Access Compliance Report

Public Rights-of-Way

(Curb Ramps)

Intersection ID: 53640	Main Street: S_TRYON_ST	Cross Street: HOOVER_CREEK_BV	Location: SE
ADA ID: 648C02F74FA8	Ramp Type: PerpDiag	Initial Pass/Fail: Fail	Overall Compliance: No
Severity Score: 12.5			
Codes/Mitigation Info/Possible Solution		Field Measurements/Component Compliance

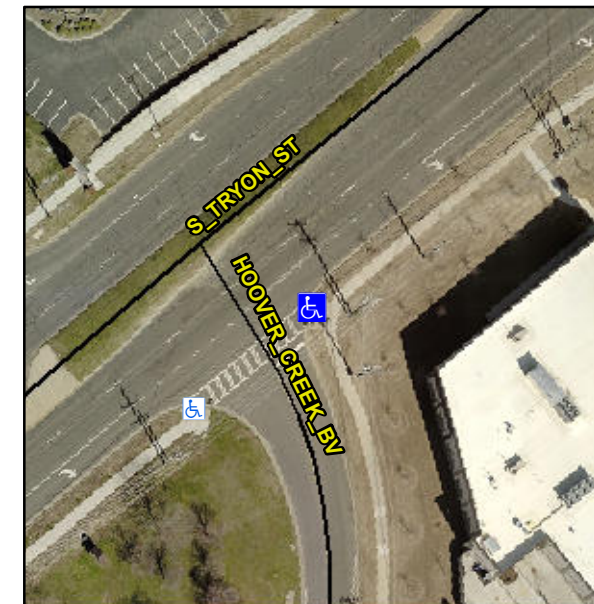
Remove & Replace Curb Ramp With Two New Directional Ramps or Equivalent.

Not Found, R304.2.2
